Access Compliance Report Public Rights-of-Way (Curb Ramps)

| Intersection ID: 30124 | Main Street: CLOONEY_LN | Cross Street: OLDE_JUSTIN_PL | Location: NE |
| ADA ID: 2B19F9FAB2E7 | Ramp Type: PerpDiag | Initial Pass/Fail: Fail | Overall Compliance: No Severity Score: 8.75 |

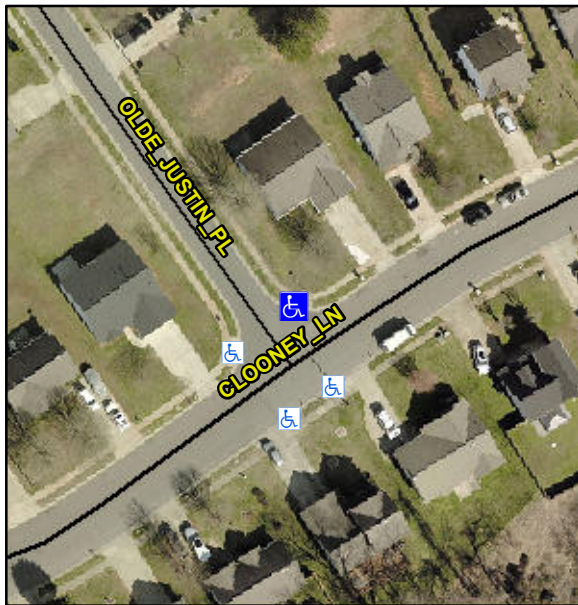
Not Found, R304.5.1

| Compliance | Description | Data | Compliance | Description | Data |
|------------|-----------------------|-------|------------|-----------------------------|------|
| No | Ramp Width (in) | 43.5 | Yes | Ramp XSlope (%) | 1.1 |

Remove & Replace Curb Ramp With Two New Directional Ramps or Equivalent.
